ADMINISTRATIVE AMENDMENT

A1 SITE PLAN 1" = 20'-0" 0 10' 20' 40'

Table with 2 columns: REVISIONS, ADDENDUM #001. Includes dates and revision numbers.

DRAWN BY: JD, TC; REVIEWED BY: CM; DATE: 10/30/2018; PROJECT NO: 18-0087; DRAWING NAME: SITE PLAN

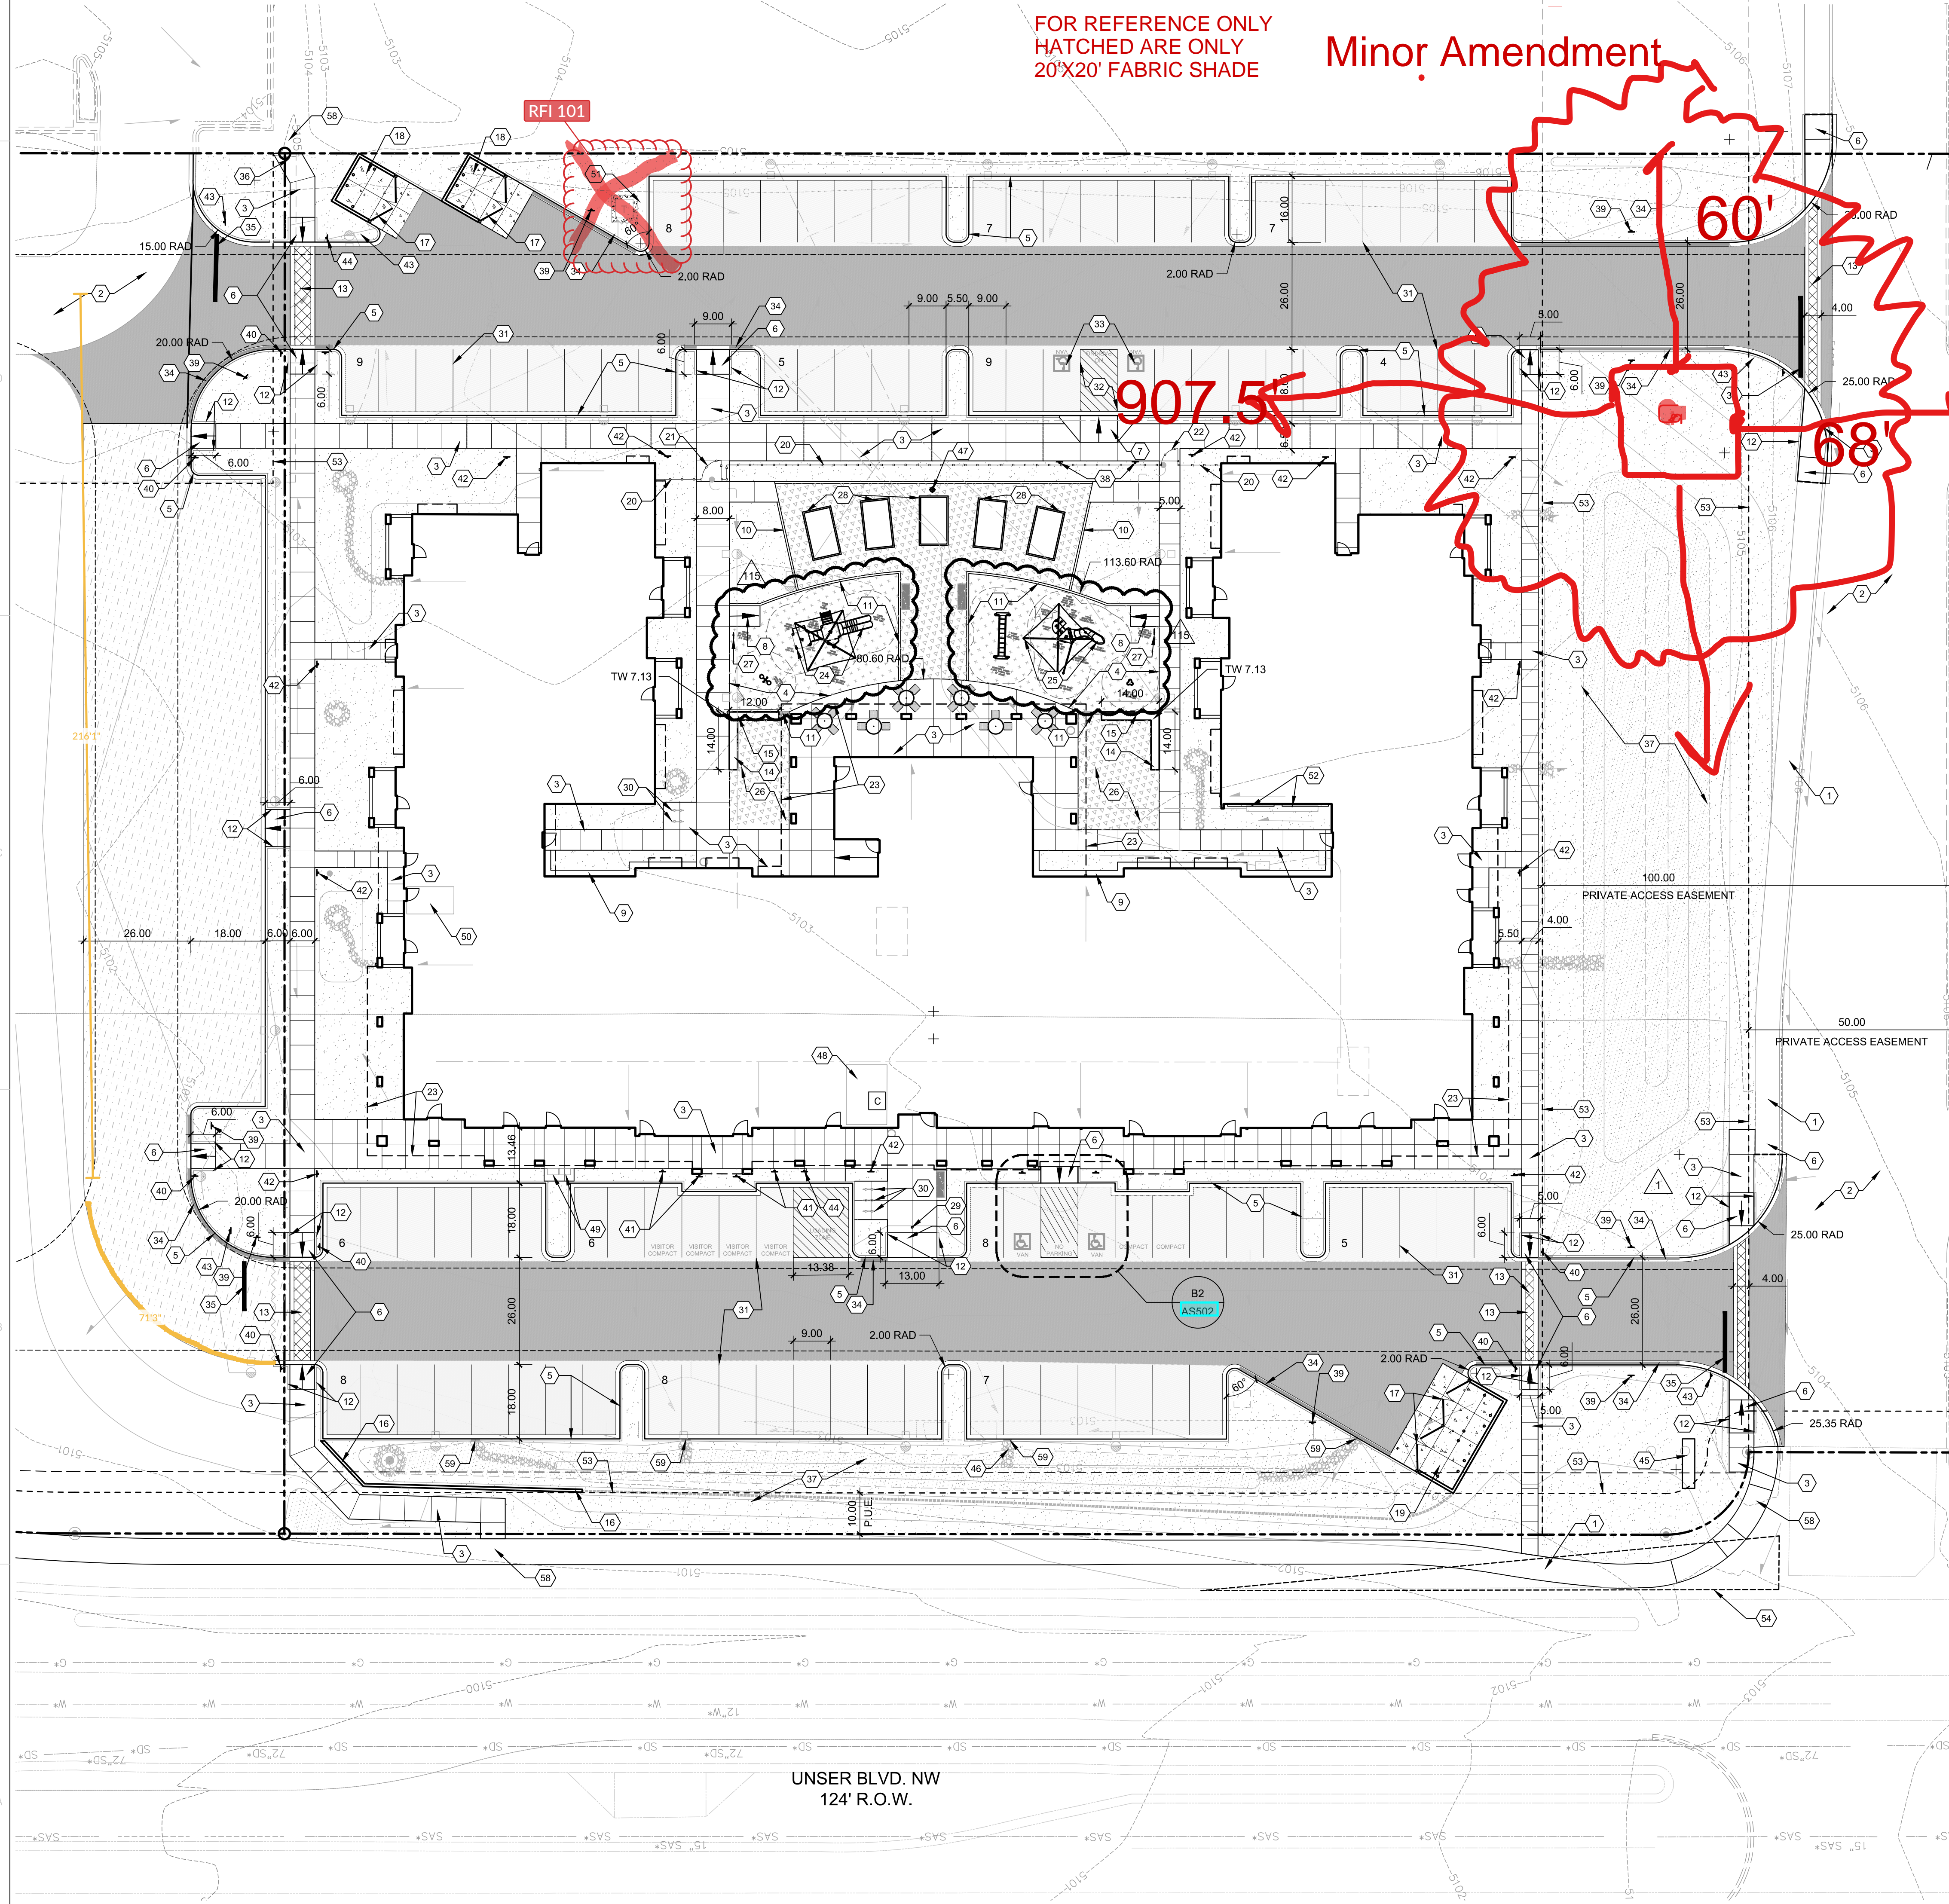
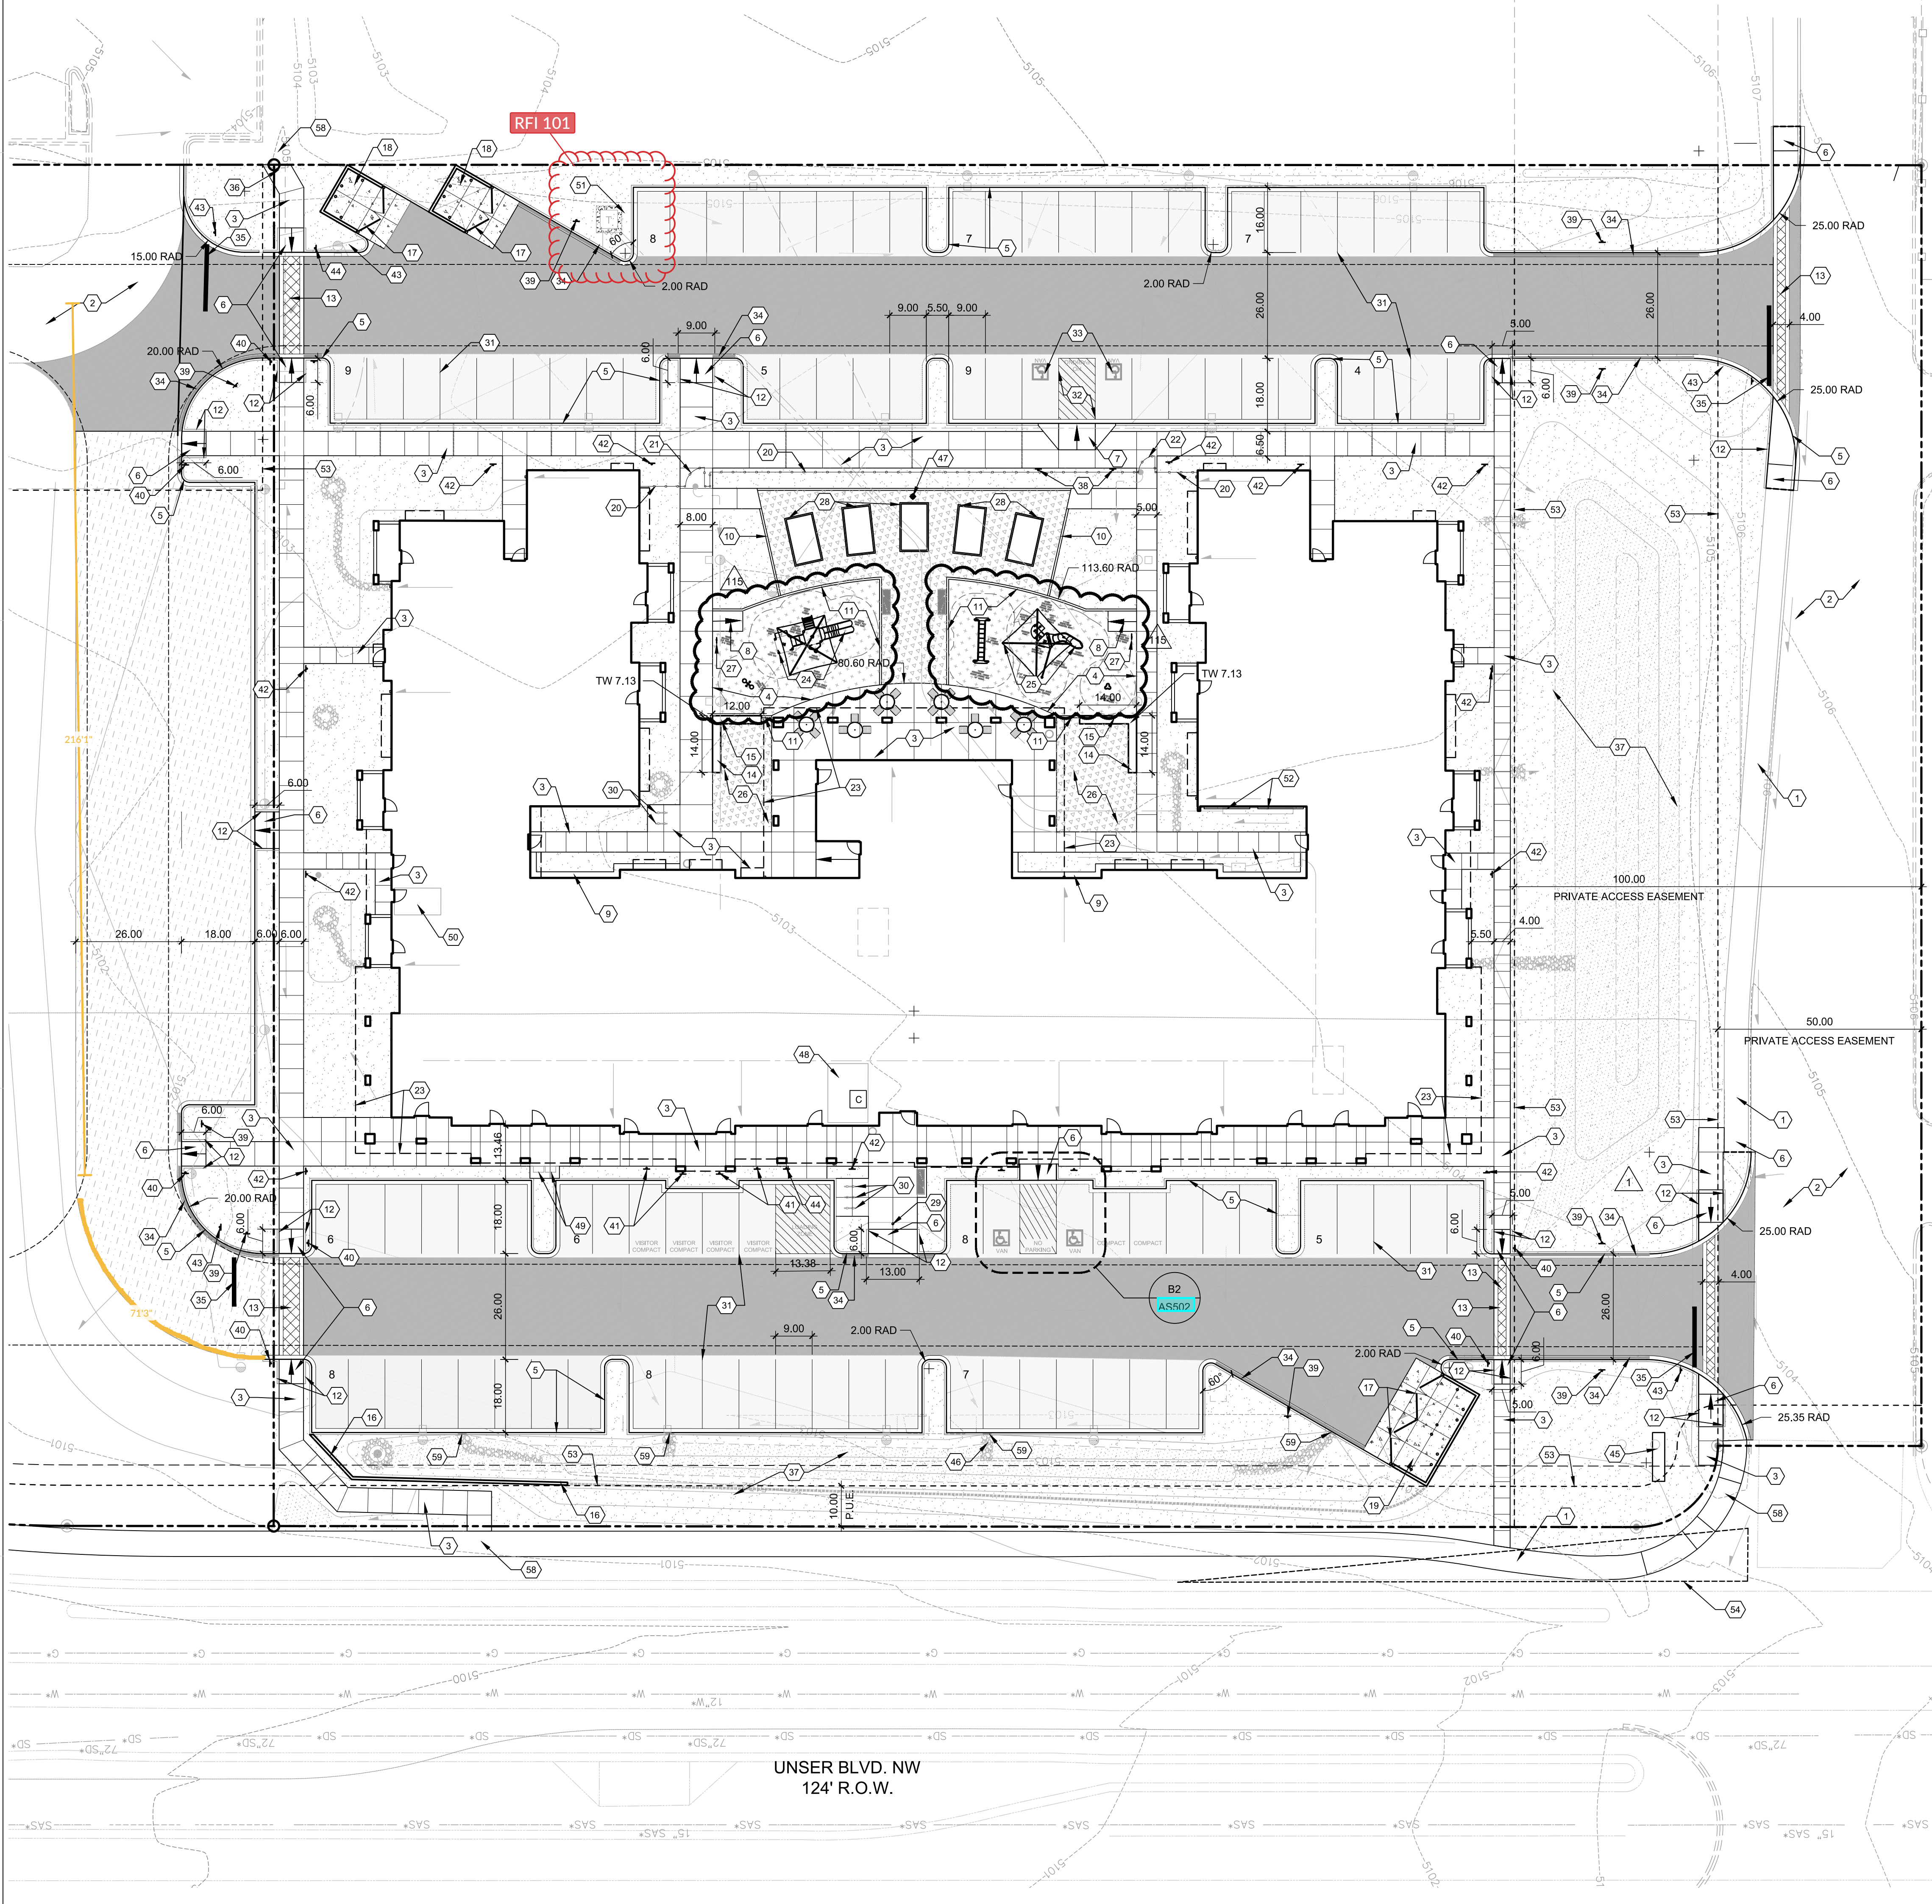
BICYCLE PARKING: IDO REQUIREMENTS (TABLE 5-5-5): RESIDENTIAL USE: 10% OF REQUIRED OFF-STREET PARKING SPACES (86) = 9 BICYCLE SPACES REQUIRED MFA 2018: PARKING FOR BICYCLES SHALL BE PROVIDED AT A RATIO OF .5 BICYCLE PARKING SPACE PER UNIT = 43 SPACES REQUIRED LEED: LONG-TERM BICYCLE STORAGE CAPACITY REQUIRED = 56 SPACES COVERED AND 5 SHORT TERM COVERED SPACES PROVIDED BICYCLE SPACES = 98 (80 ARE LOCATED IN AN INDOOR BICYCLE STORAGE ROOM, AND 10 ARE LOCATED OUTDOORS)
